**Historical Architectural Review Board  
COA Final Review Sheet**

**HDC-2023-00079**

**Address: 201 N. 10th St**

**Proposal: Apply stucco to brick wall at side of property**

North façade of 201 N 10<sup>th</sup> Street, 2023.  
(Applicant)

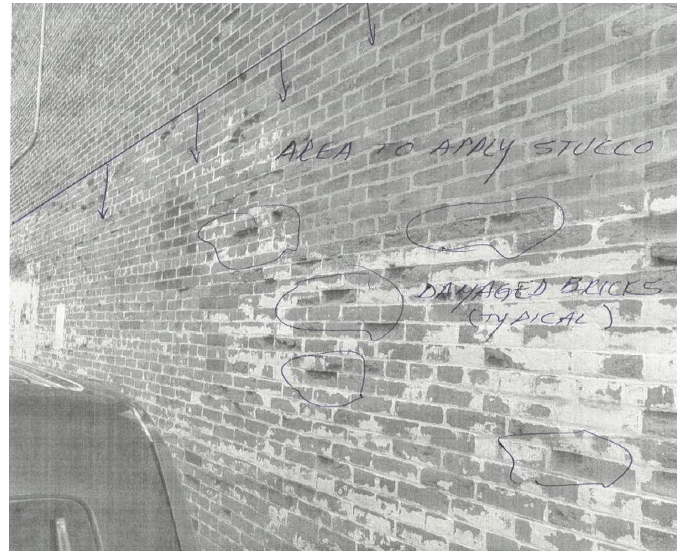
A building historically stood on the adjacent property at 203 N. 10<sup>th</sup> Street and was demolished at some point in the past, leaving the two adjoining party walls exposed to the elements. Owing to the exposure, the north elevation of 201 N. 10<sup>th</sup> Street contains soft, porous brick that has been deteriorating since the demolition of the adjacent structure. To stabilize the brick, the applicant is proposing to apply stucco over reinforced wire mesh fastened to the mortar joints. While Guideline 3.3.7 advises against painting, coating, or sealing historically unpainted brick, staff notes that party walls are an exception, since the brick of these walls was never intended to be exposed to the elements. The brick at party walls is significantly weaker than the high-fired brick of a typical building façade. Because of the susceptibility of the brick to deterioration, staff finds coating a portion of the wall to be an appropriate intervention, provided the stucco is compatible. Staff further notes that the exposed party wall at 205 N. 10<sup>th</sup> Street has already been stuccoed.

An appropriate stucco should be softer than the brick to avoid exacerbating the deterioration. Staff recommends using a lime-based stucco and points to guidance provided in a National Park Service Preservation Brief regarding the preservation and repair of historic stucco, see Figure 1 below:

Staff also advises against painting or sealing the stucco to avoid trapping moisture, which can lead to further deterioration.

Approval, provided the stucco contains a sufficient amount of lime so that it is softer than the brick, pursuant to Chapter 3, Section 3.3 Masonry.

Mr. Encelewski moved to approve the application presented on 11/6/2023 for the installation of stucco over the brick party wall of 201 N. 10<sup>th</sup> Street, pursuant to Chapter 3, Section 3.3 Masonry, provided that a softer, more compatible stucco be used. Mr. Hart seconded the motion, which carried with unanimous support.
